SUBSURFACE WASTEWATER DISPOSAL SYSTEM APPLICATION

Street or Road: 531 ISLAND AVENUE

Revised

SUBSURFACE WASTEWATER DISPOSAL SYSTEM VARIANCE REQUEST

SUBSURFACE WASTEWATER DISPOSAL SYSTEM APPLICATION

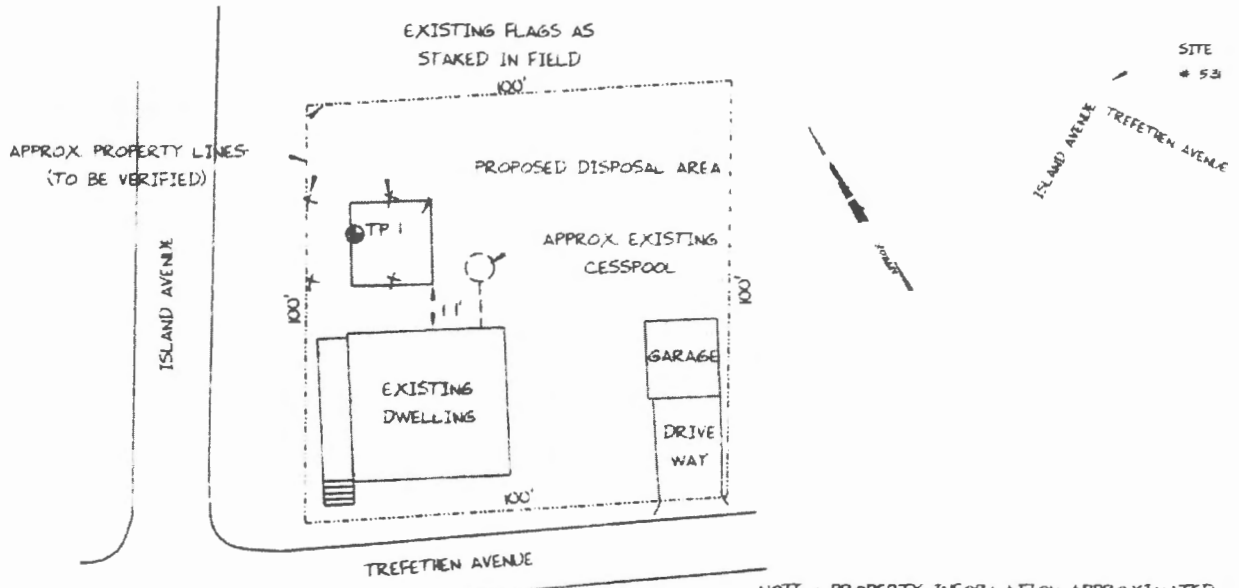
Date: **11/27/12 REVISED**

ALBERT FRICK ASSOCIATES - 95A COUNTY ROAD ROAD GORHAM, MAINE 04038 - (207) 839-5563
Note: Changes to or deviations from the design should be confirmed with the Site Evaluator

SUBSURFACE WASTEWATER DISPOSAL PLAN

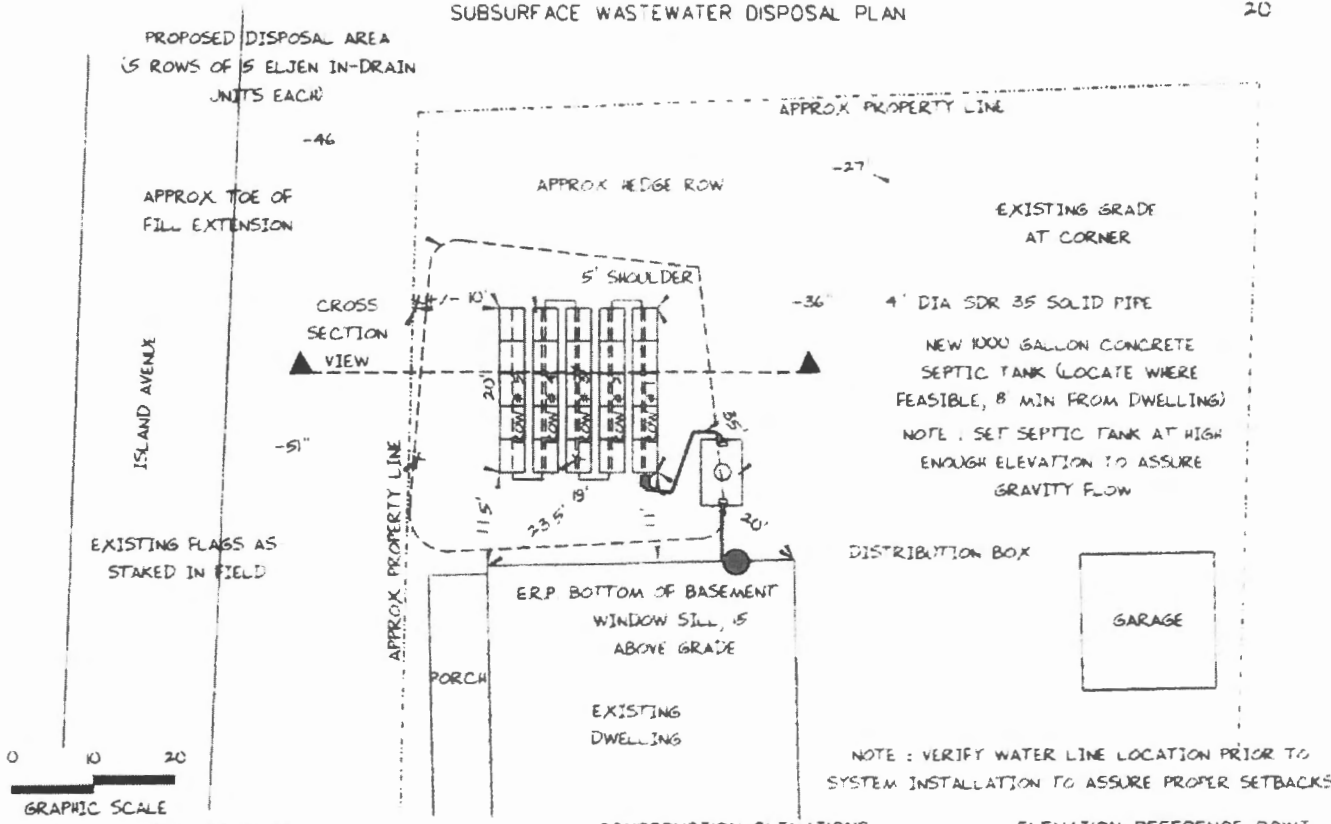
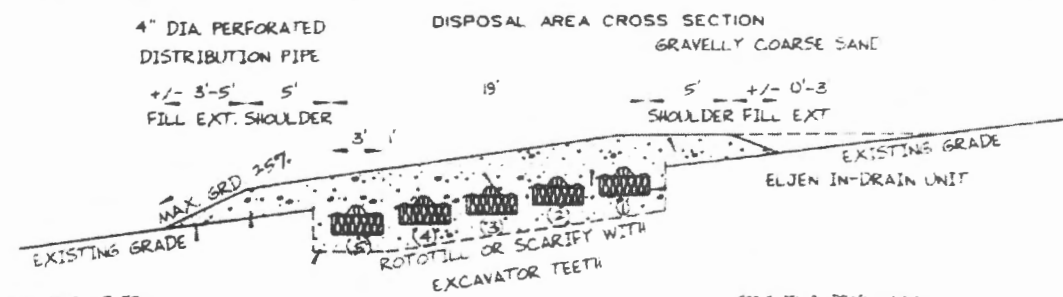
SPECIFIC VARIANCE REQUESTED (To be filled in by Site Evaluator. Use additional sheets if needed.)	SECTION OF RULE
1. <u>To allow a replacement disposal field to be installed 11' from a full foundation</u>	<u>8 (Table 8 A)</u>

11/27/12 REVISED
